**Addendum #1**  
**June 10, 2024**

**Westbrook Armory MOV/POV Compound Project, Westbrook, Maine - Project No. 23SR19-428-D**  
**Bid Number #24-047**

Directorate of Facilities Engineering

SHEET ID:  
CD-101  
SHEET: 3 of 17

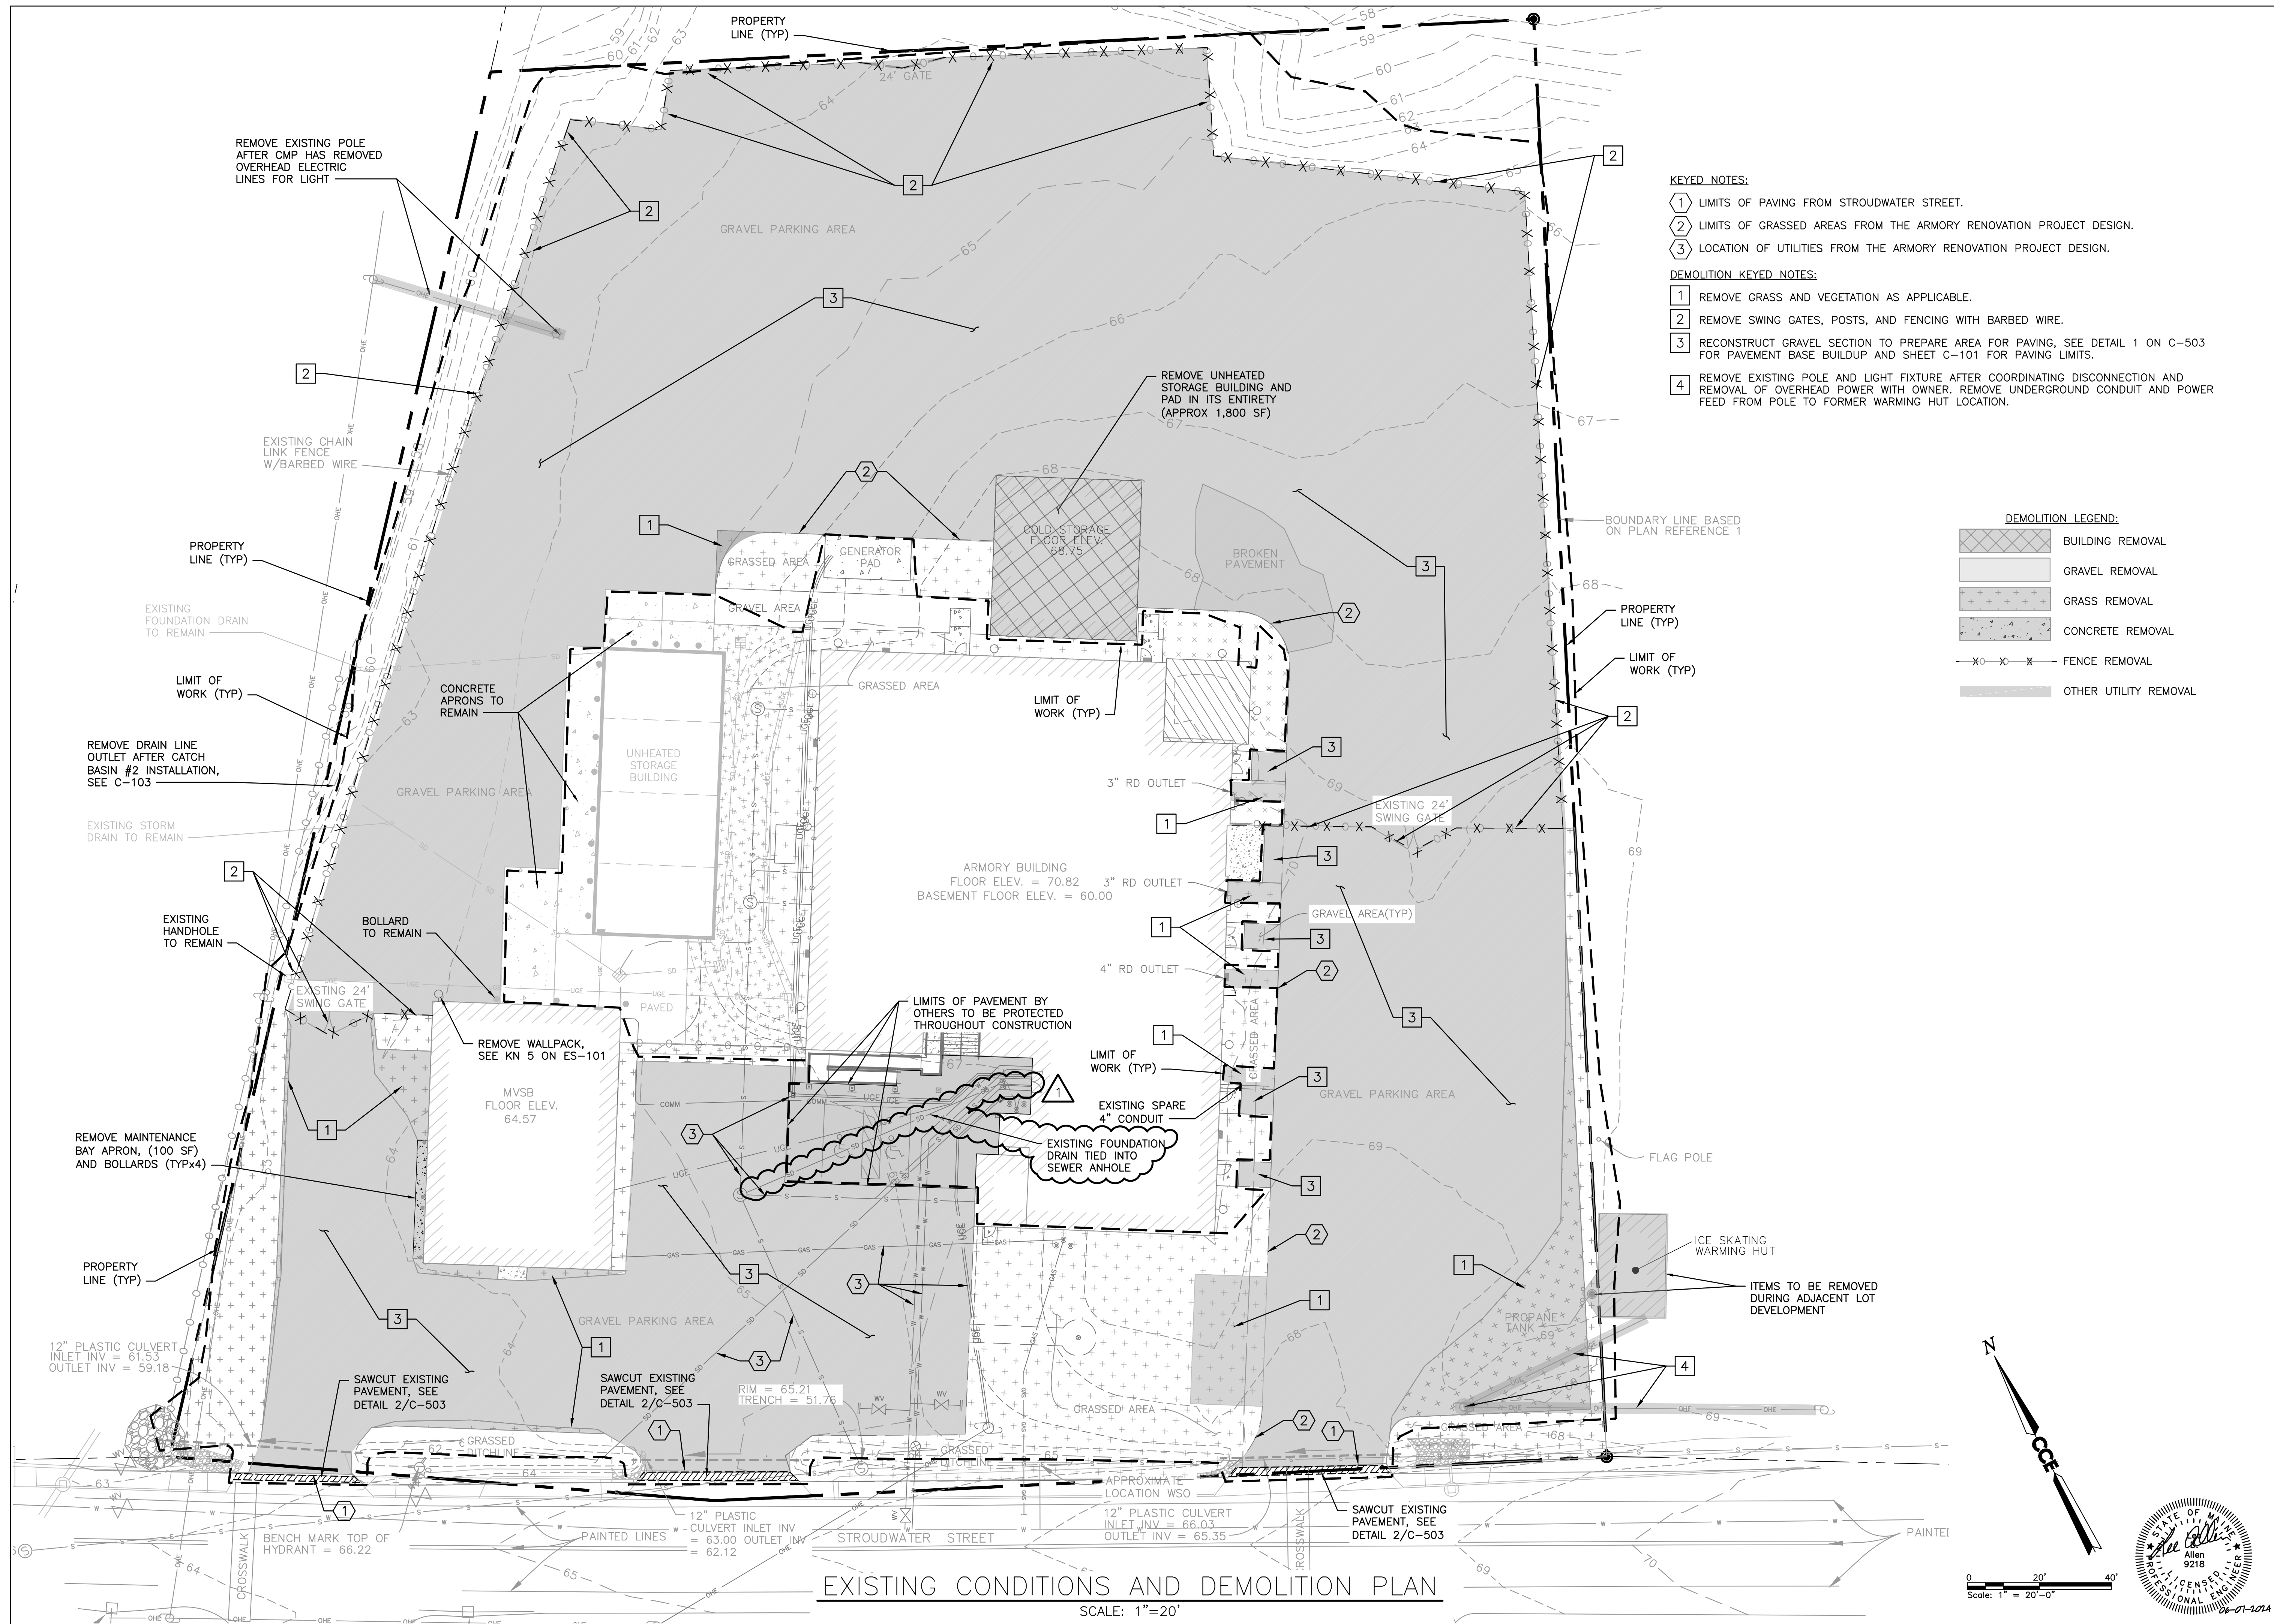
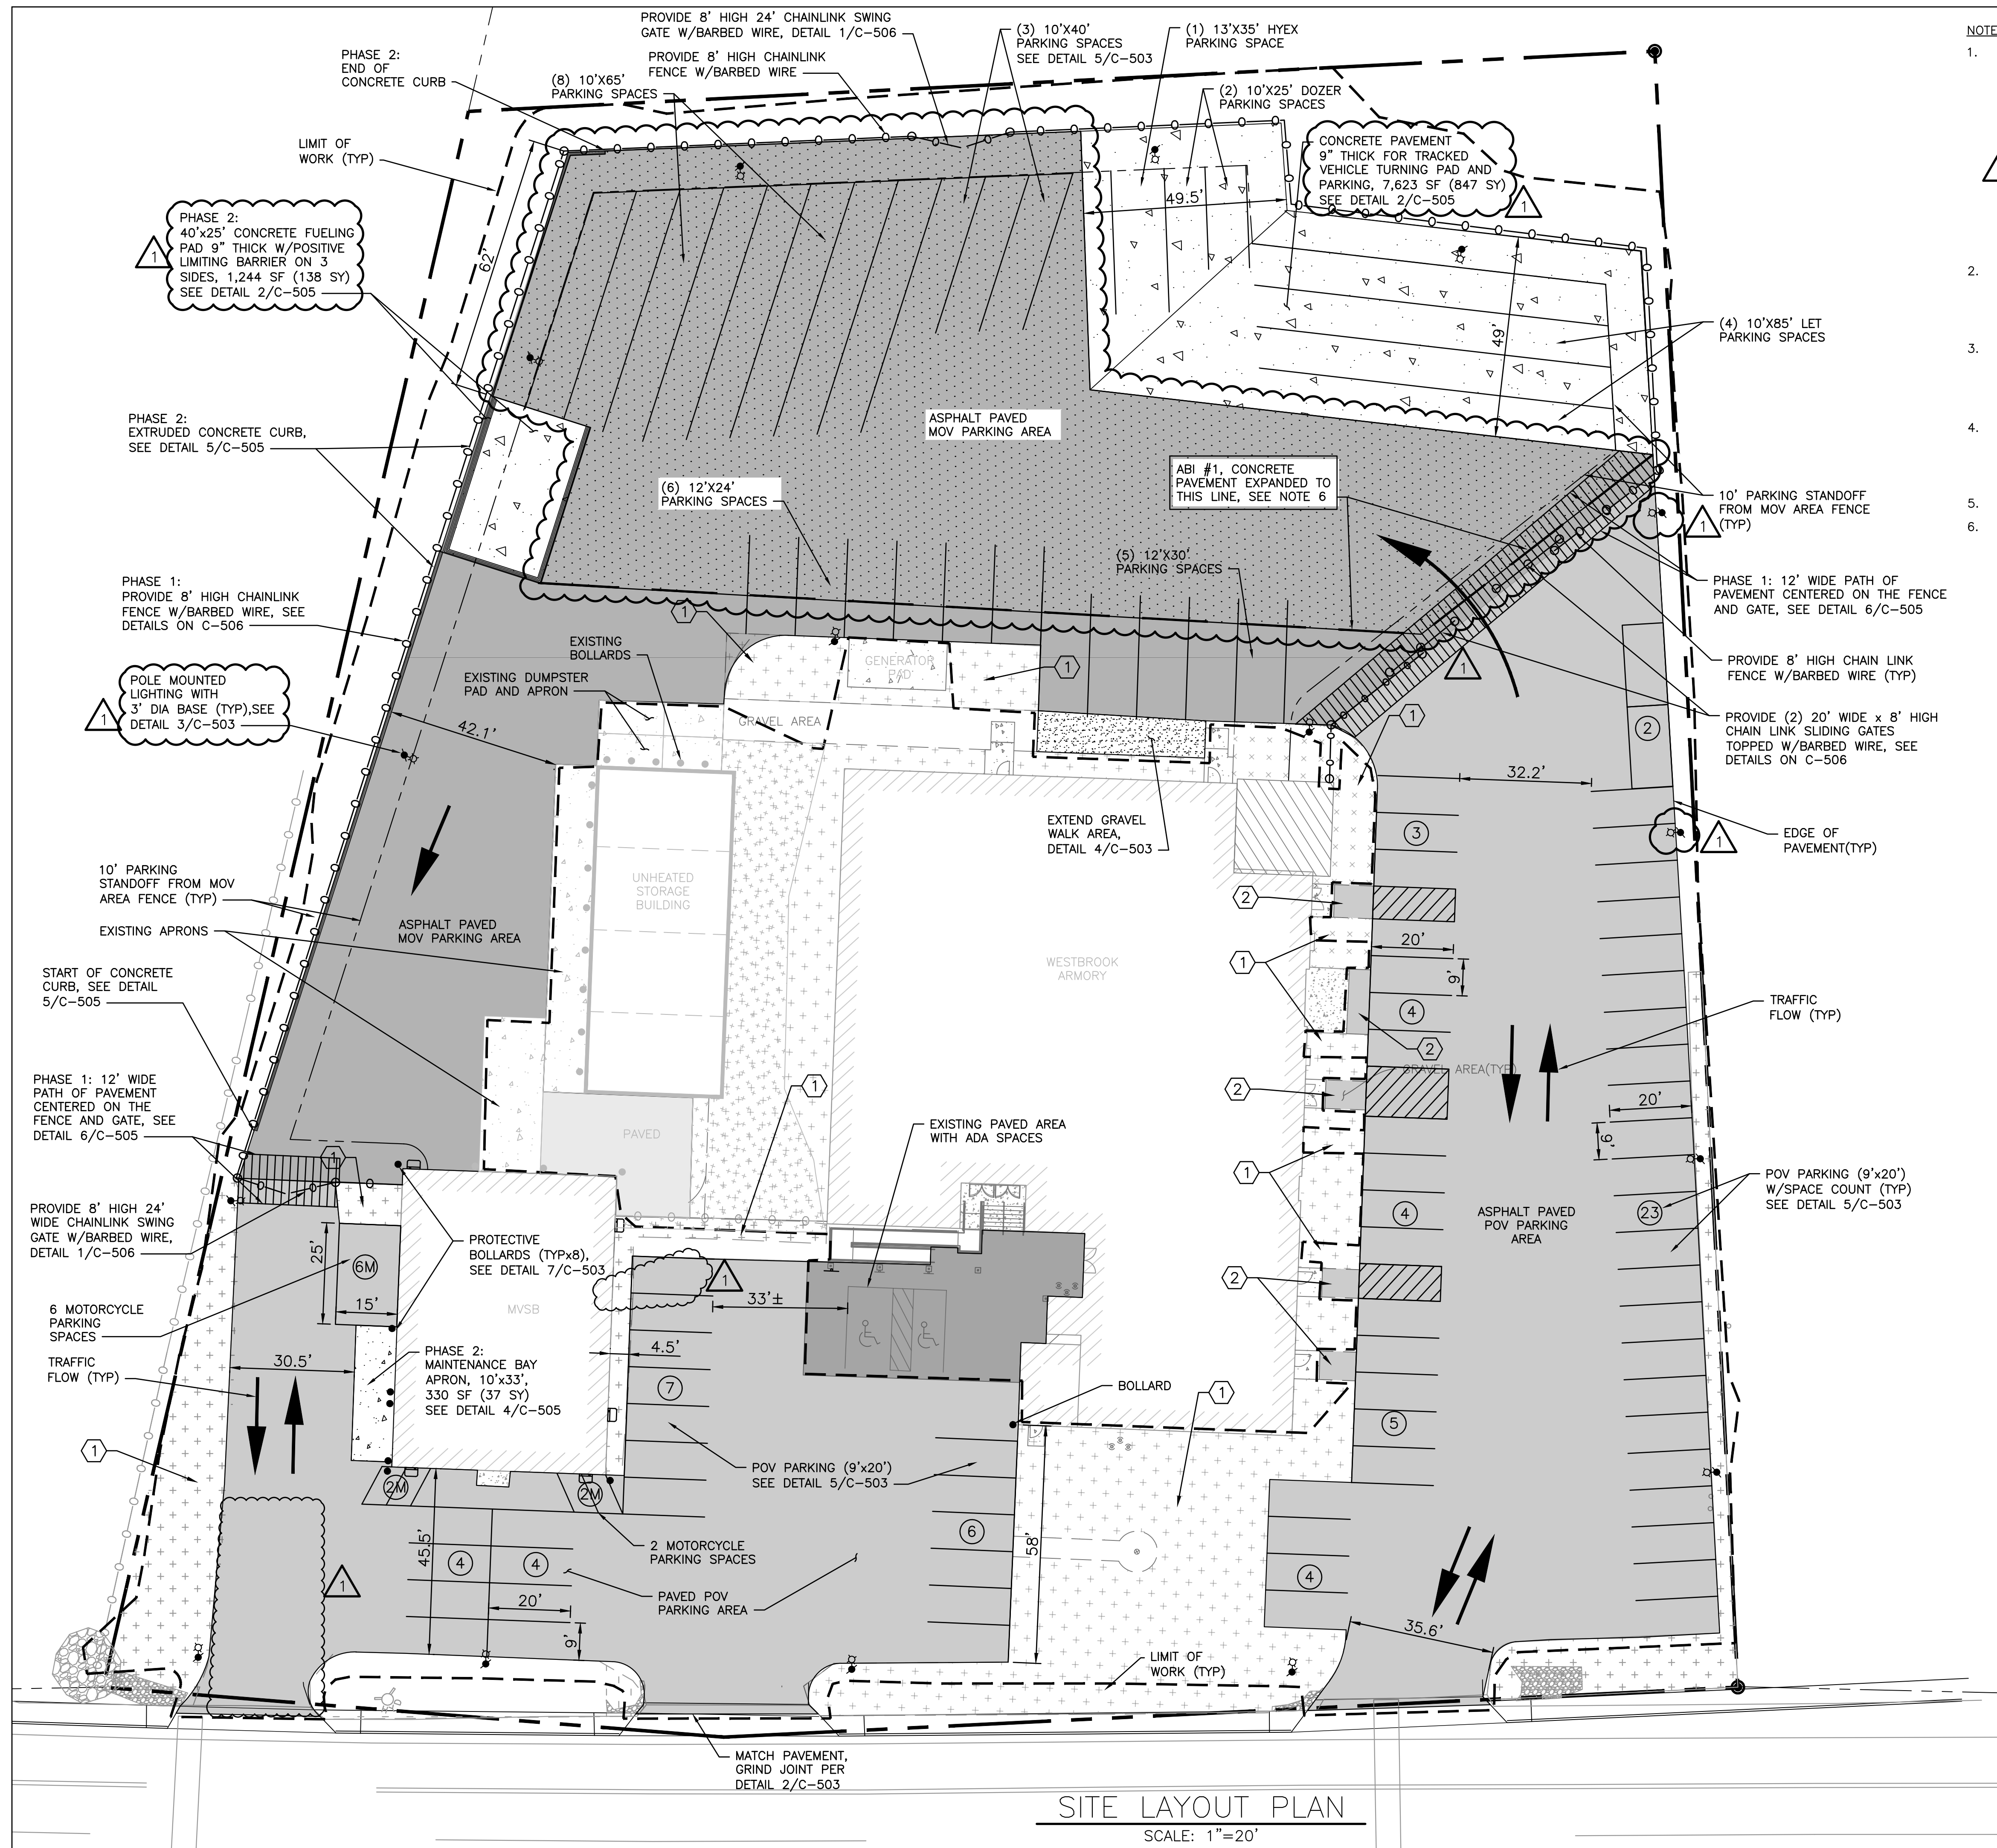
- b. C-001 - Corrects error on AHJ for permitting for this project. Also removes note for expired Maine DOT moratorium for Stroudwater Street.
  - c. CD-101 - Shows the existing foundation drain not present in original drawing. Was initially part of this project but is now removed.

4. The storm drain / roof drains and associated cleanouts highlighted in green will either be installed with the current work being done, stubbed to outside the current work area, or will need to be installed and the new pavement getting placed on current project will have to be excavated and repaved. **The foundation /roof drain was constructed as part of the Armory Renovation Project and is no longer part of this project. It has been deleted from the plans.**

**SITE LAYOUT PLAN**  
 SCALE: 1"=20'

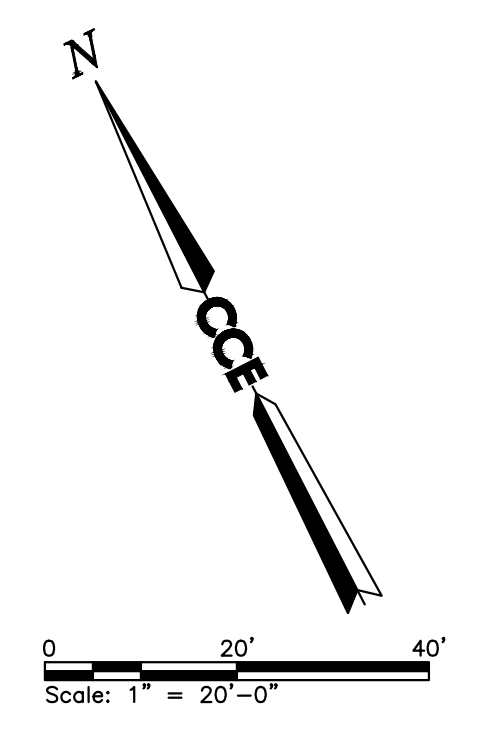
- d. C-101 - Corrects discrepancy between this sheet and referenced detail from original bid documents regarding concrete thickness. Also eliminates EV charging station and shows an adjusted location for light poles. Light pole bases are 3" in diameter. Removed Keyed note for EV charging station.

7. Plan page C-101 note on tracked vehicle turning pad states an 8” thick concrete pad. Detail 1 on page C-505 shows a 9” sectional thickness. Please clarify sectional thickness for all concrete pads. **The tracked vehicle pad and fueling pad are 9” thick.**

11. Light pole bases on drawing C-101 says 2' diameter; detail D-3 on drawing C503 says 3' diameter. **All light pole bases are 3' in diameter. Please note that the locations of two light poles on the east side of the site have been moved off the pavement.**
